DATE: July 11, 2012

TO: All Prospective Bidders

SUBJECT: Addendum No. 2
 US 50 HOV Lanes Phase 0 El Dorado Hills Interchange
 Project
 Contract No. PW 12-30639, CIP No. 53124

**CONSTRUCTION DETAILS
NO SCALE
C-4**

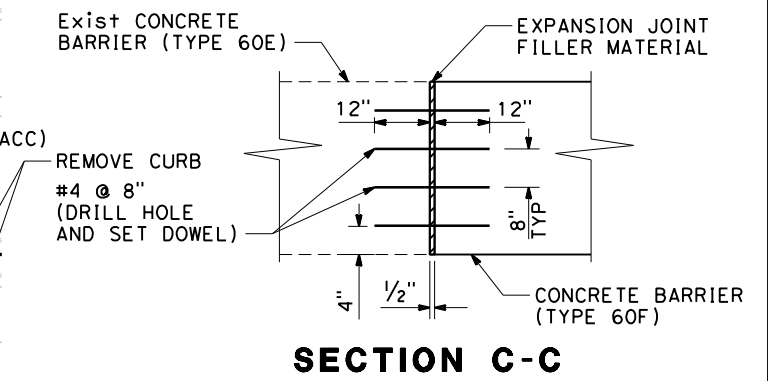
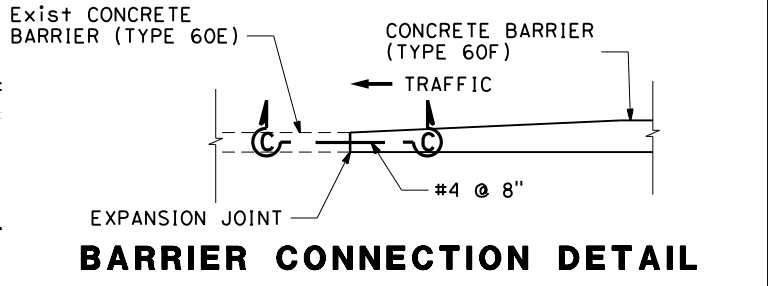
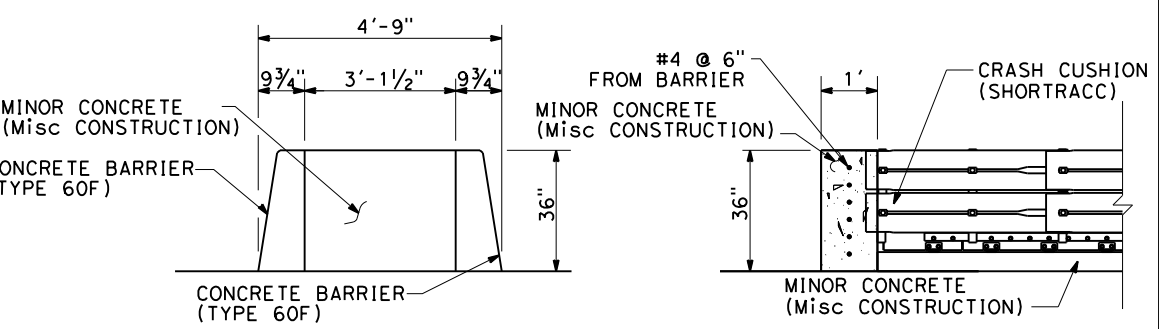
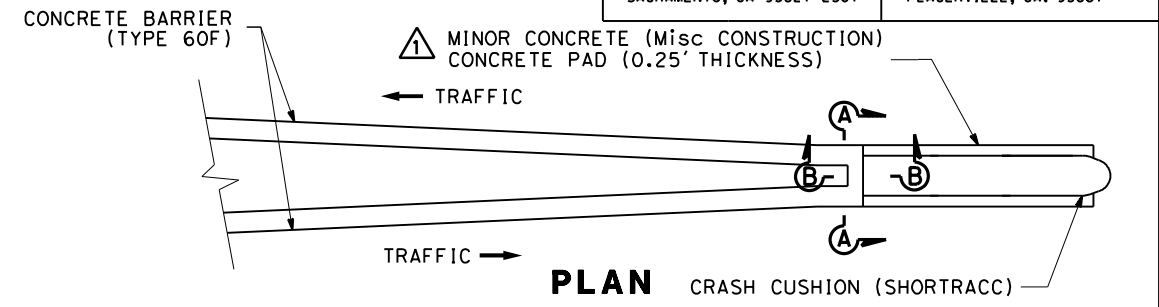
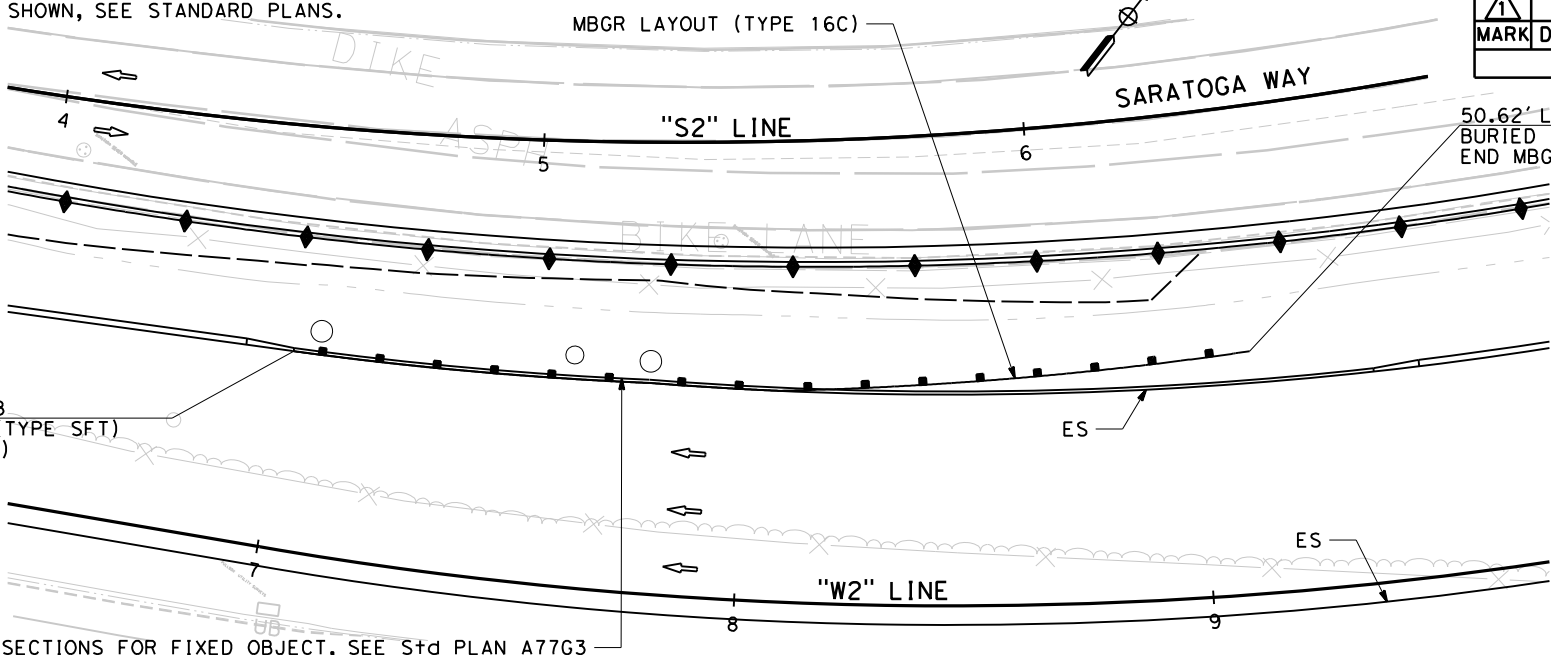
MARK	DATE	DESCRIPTIONS	BY	CH'D
1	7-12	CONCRETE PAD REVISION	VFD	CG3
		REVISIONS

UTILITY PLAN
 SCALE: 1"=50'
U-2

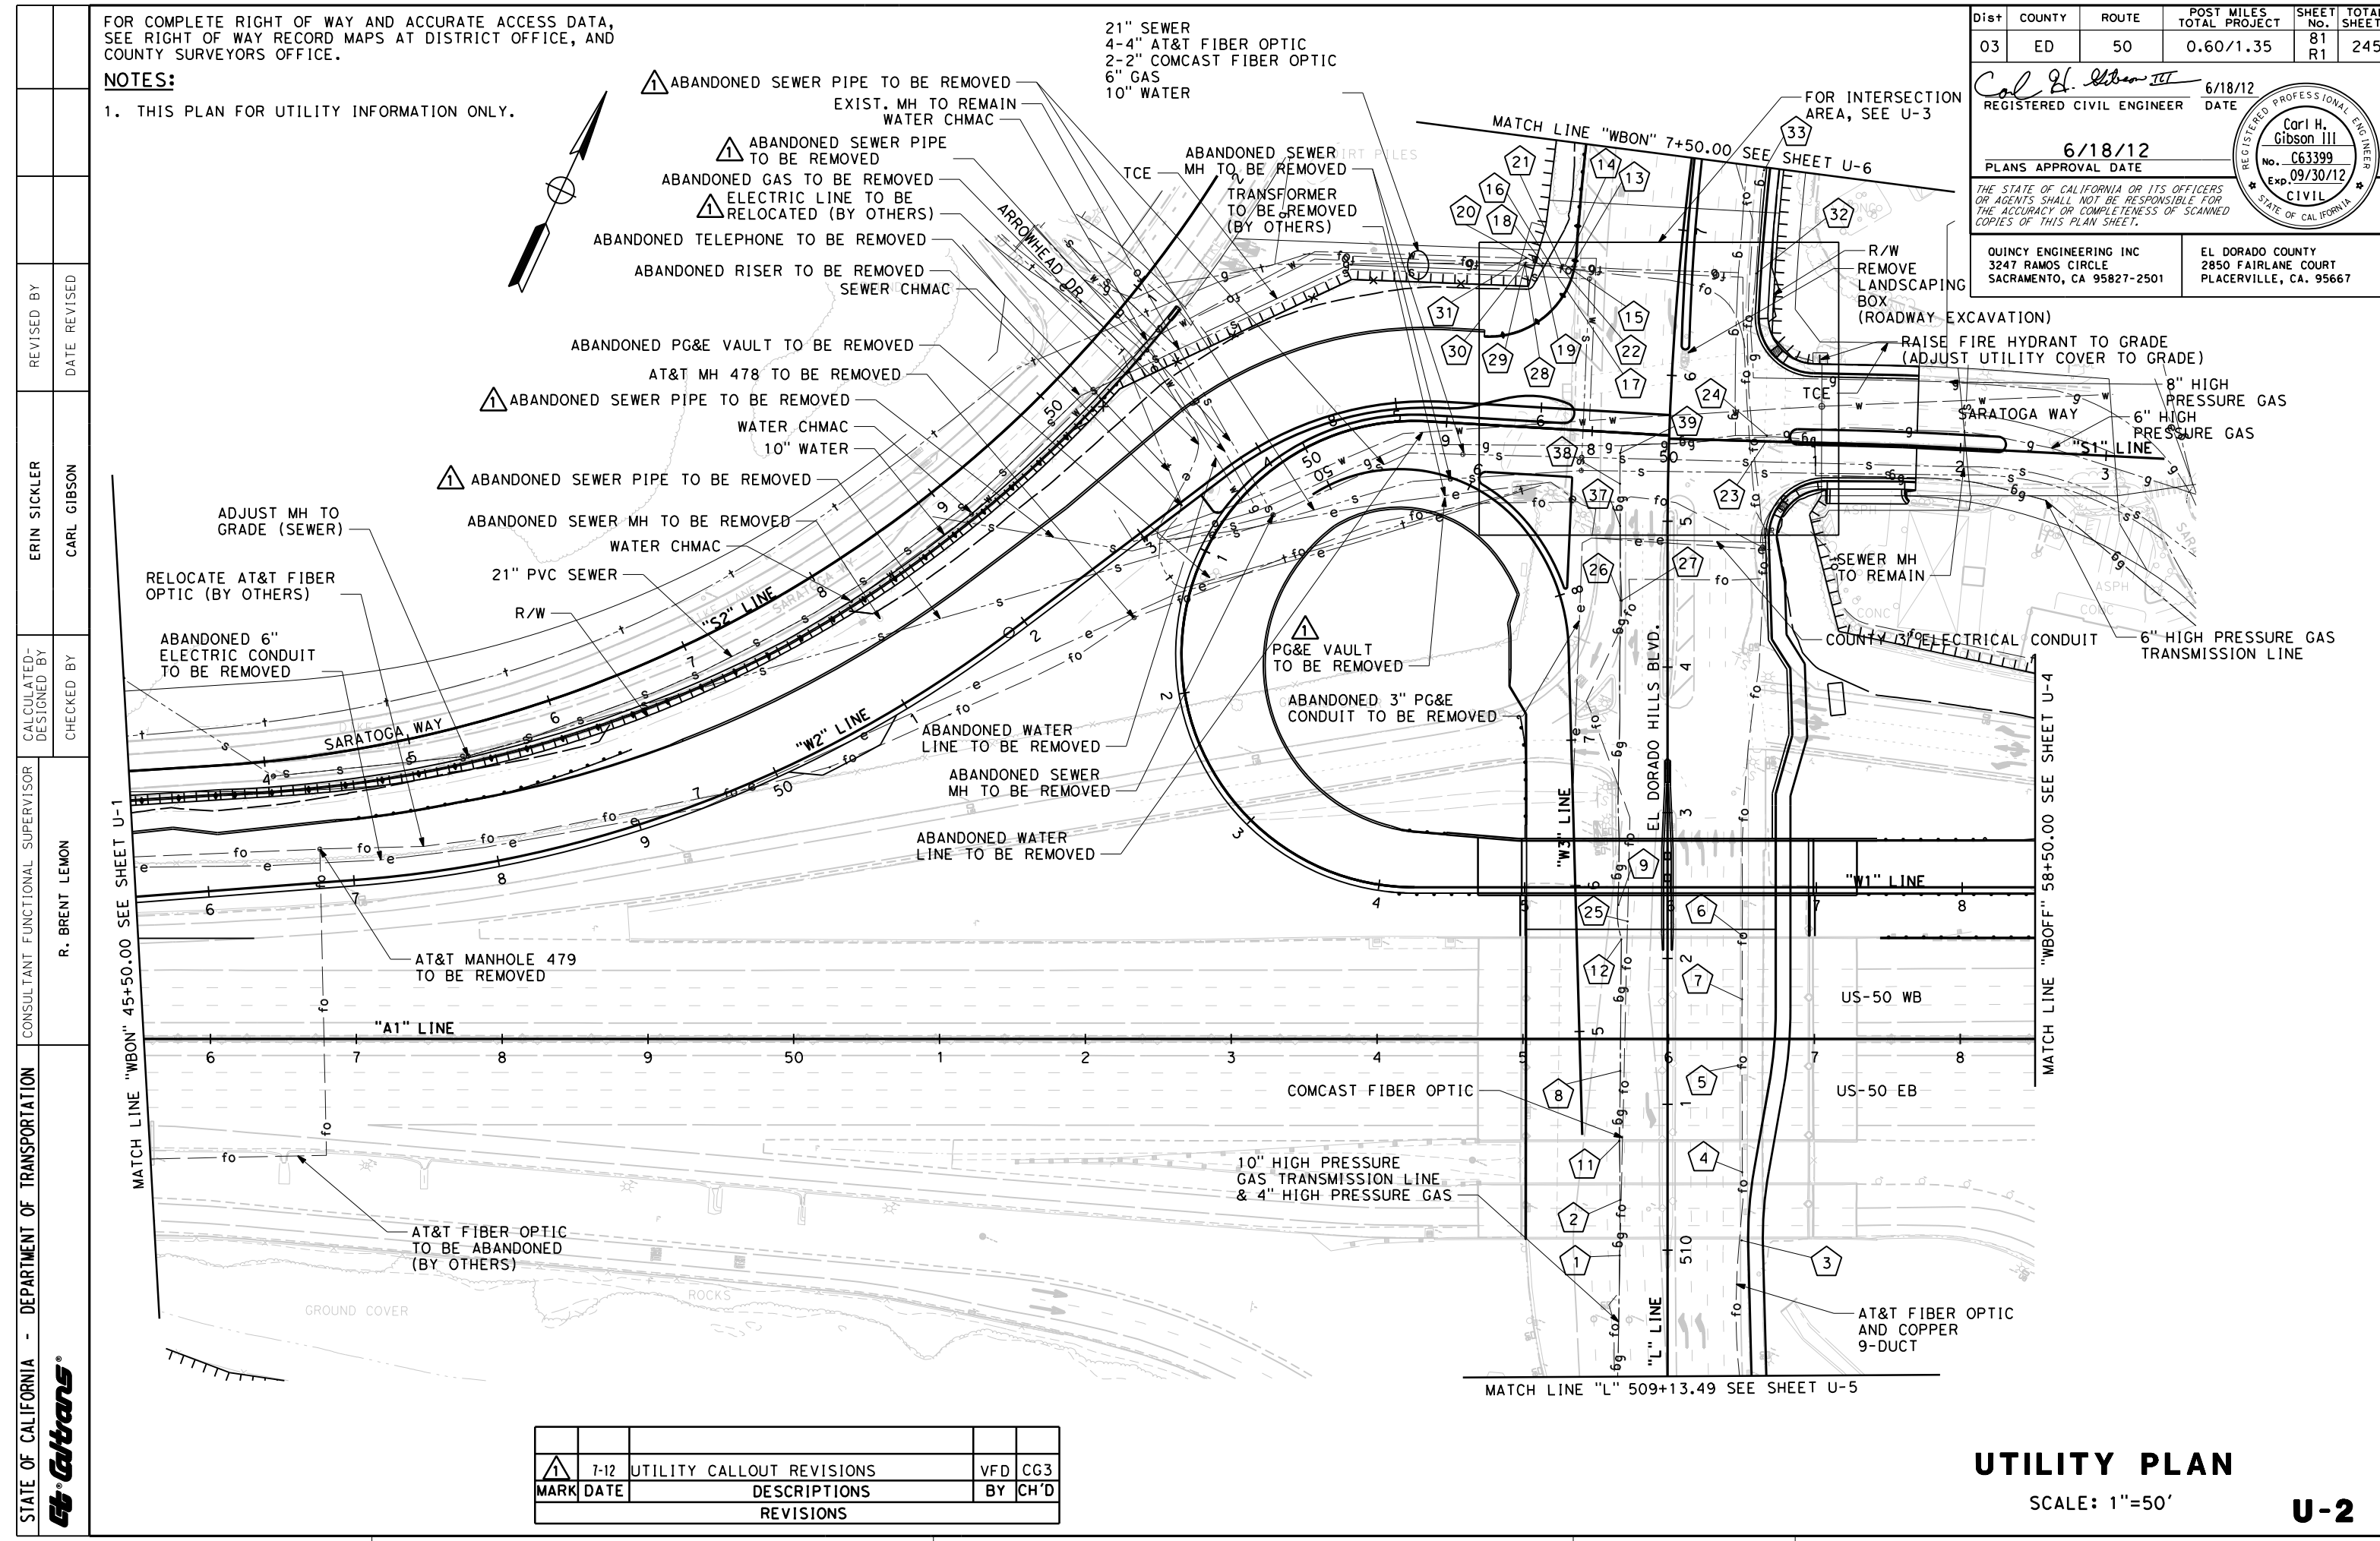
MARK	DATE	DESCRIPTIONS	BY	CH'D
△	7-12	UTILITY CALLOUT REVISIONS	VFD	CG3
REVISIONS

- △ ABANDONED SEWER PIPE TO BE REMOVED
EXIST. MH TO REMAIN
WATER CHMAC
- △ ABANDONED SEWER PIPE TO BE REMOVED
- △ ABANDONED GAS TO BE REMOVED
- △ ELECTRIC LINE TO BE RELOCATED (BY OTHERS)
- ABANDONED TELEPHONE TO BE REMOVED
- ABANDONED RISER TO BE REMOVED
SEWER CHMAC

UTILITY PLAN
SCALE: 1"=20'
U-3

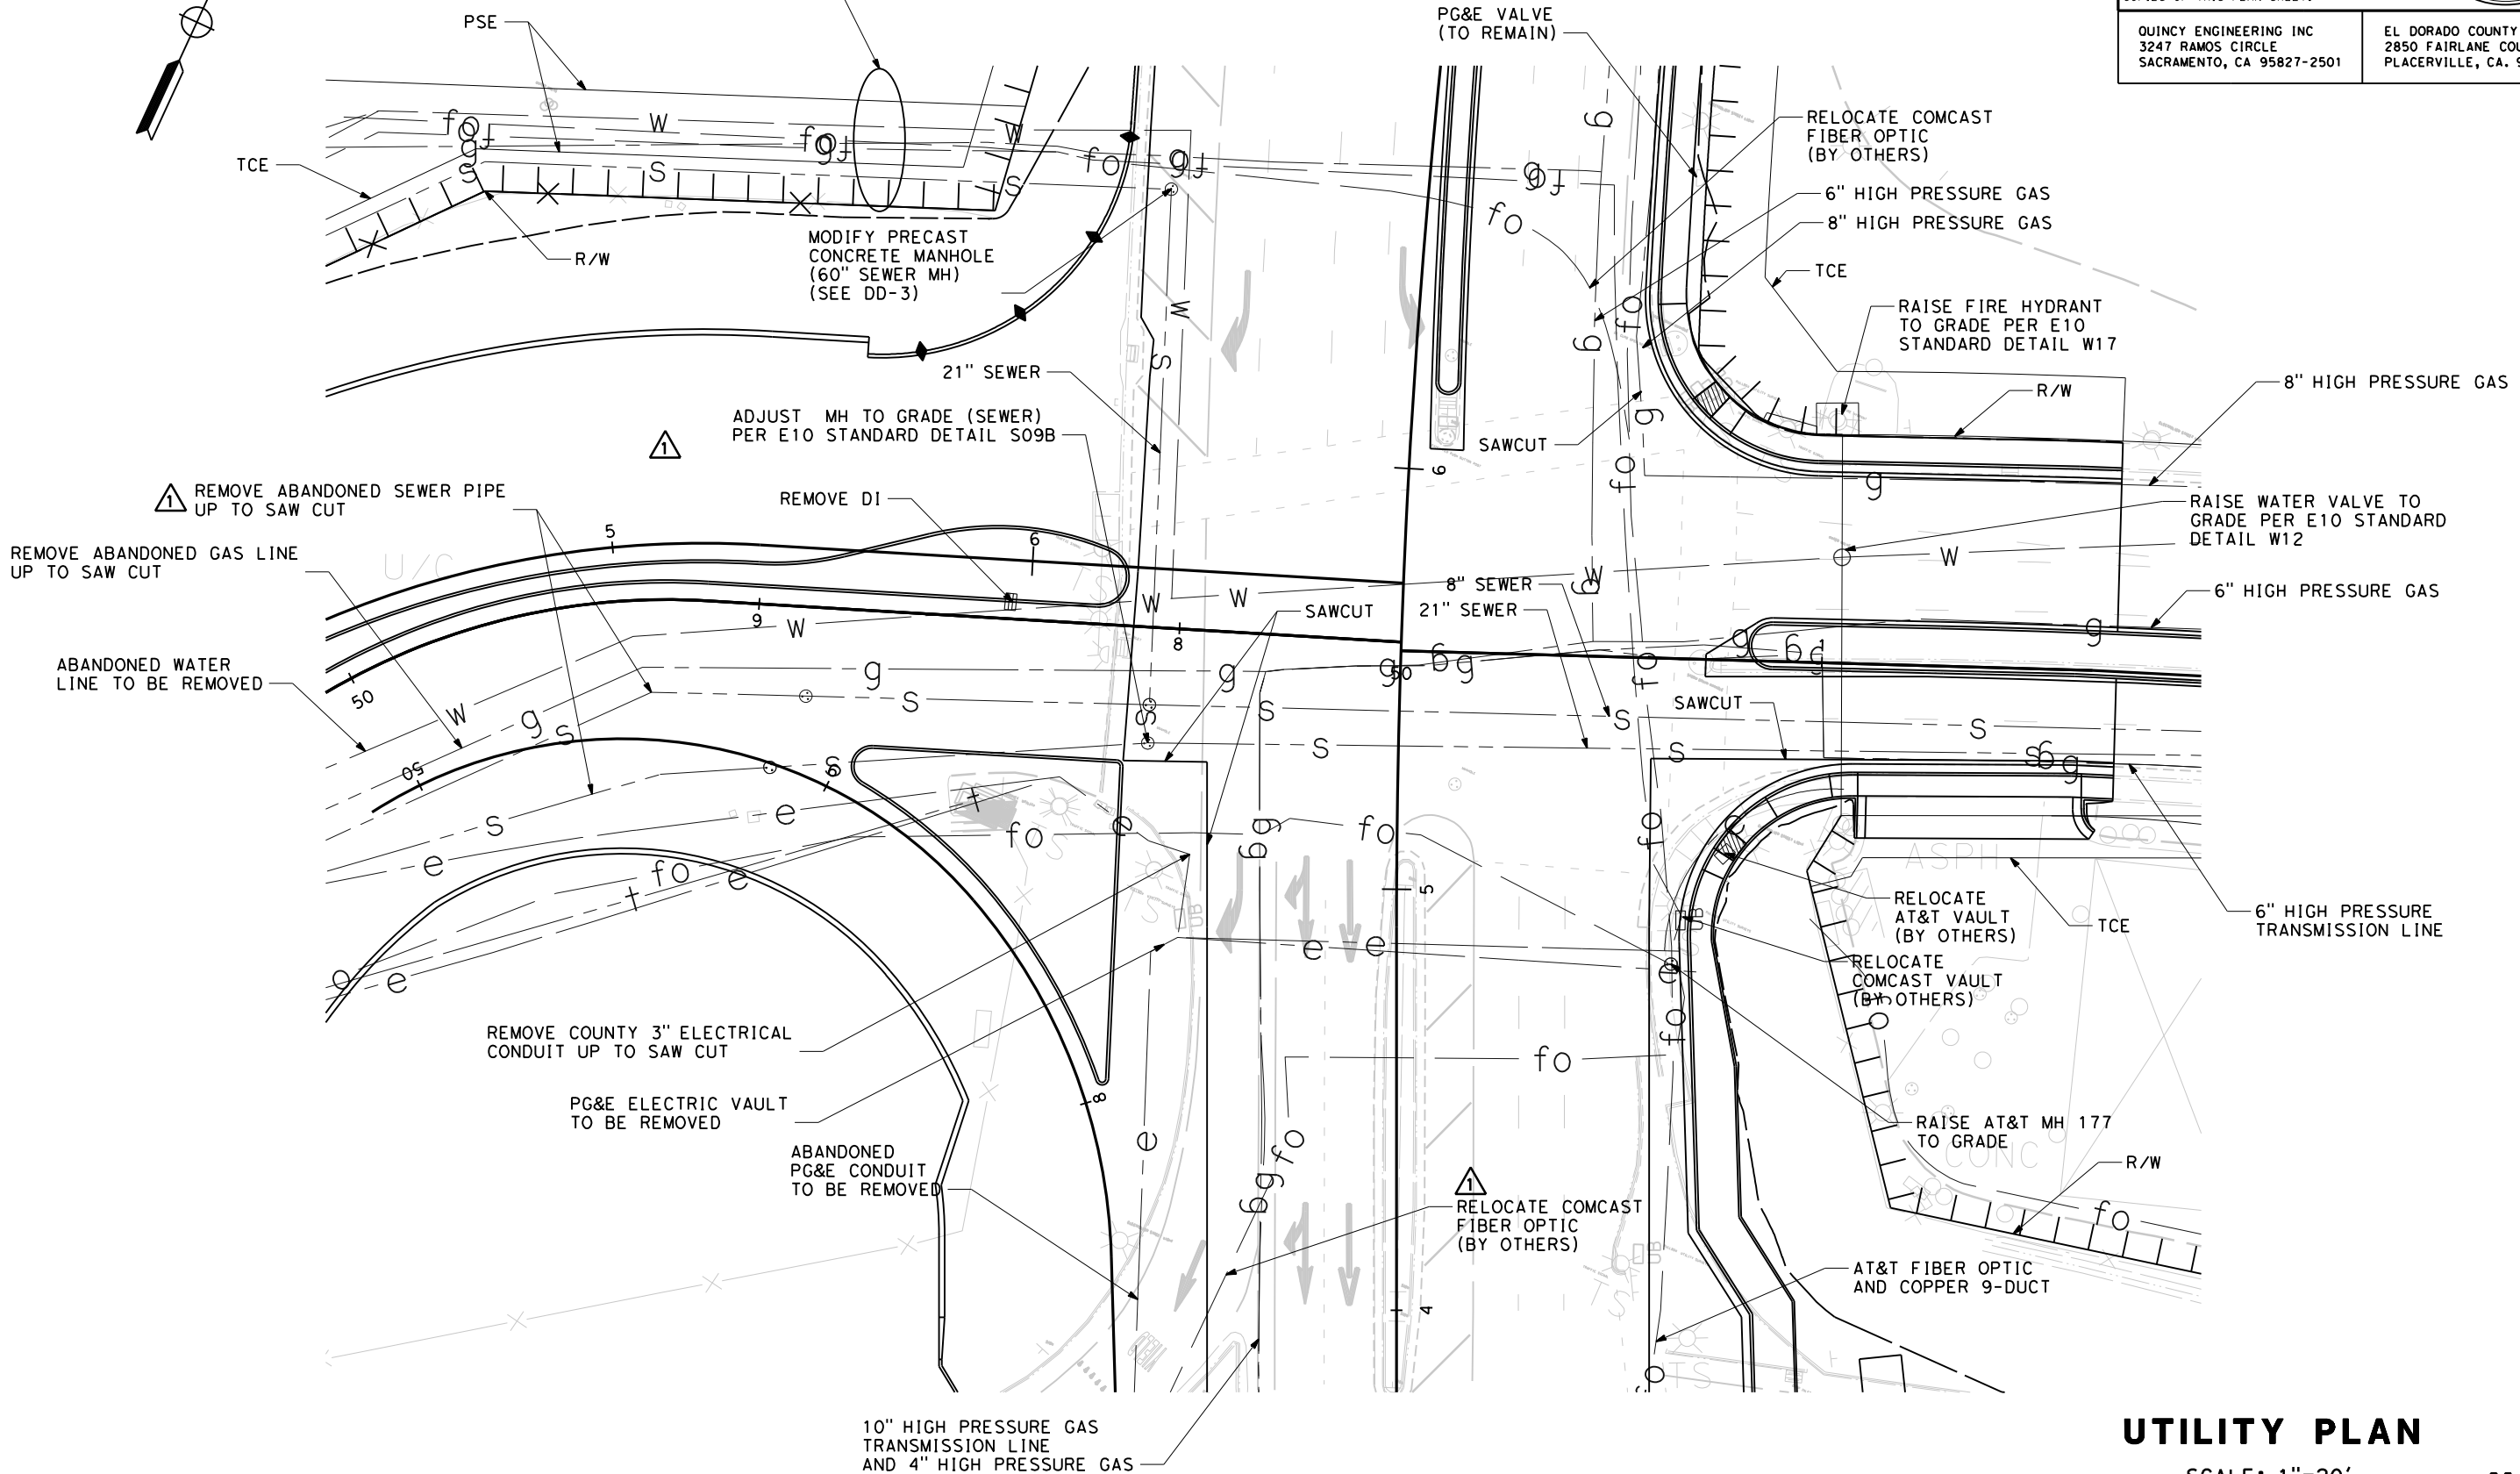
MARK	DATE	DESCRIPTIONS	BY	CH'D
1	7-12	UTILITY CALLOUT REVISIONS	VFD	CG3
		REVISIONS
